ACPE IWG #10

00 series Text amendment

- > 5.1.2 Pedal Maneuver
- > 5.2.2 Long term deactivation
- > 5.2.3.1.3.1 Relationship with other systems

5.1.2 Pedal Maneuver

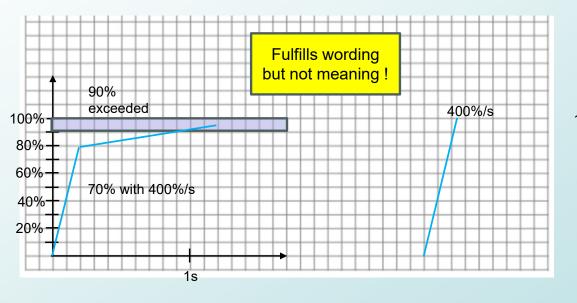
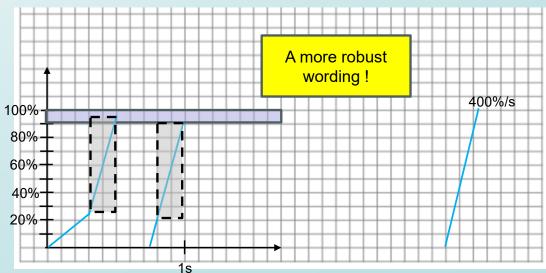
5.1.2. An accelerator control application having a velocity of at least 400 per cent per second over a travel distance of at least 70 per cent of the total travel distance of the accelerator control, and reaching a maximum position of the accelerator control of at least 90 per cent, shall be regarded as an accelerator control misapplication in the context of the paragraph 5.1.1

5.1.2. An accelerator control application having a velocity of at least 400 per cent per second over a travel distance of at least 70 per cent of the total travel distance of the accelerator control, and reaching a maximum position of the accelerator control of at least 90 per cent within the above 70 per cent travel shall be regarded as an accelerator control misapplication in the context of the paragraph 5.1.1
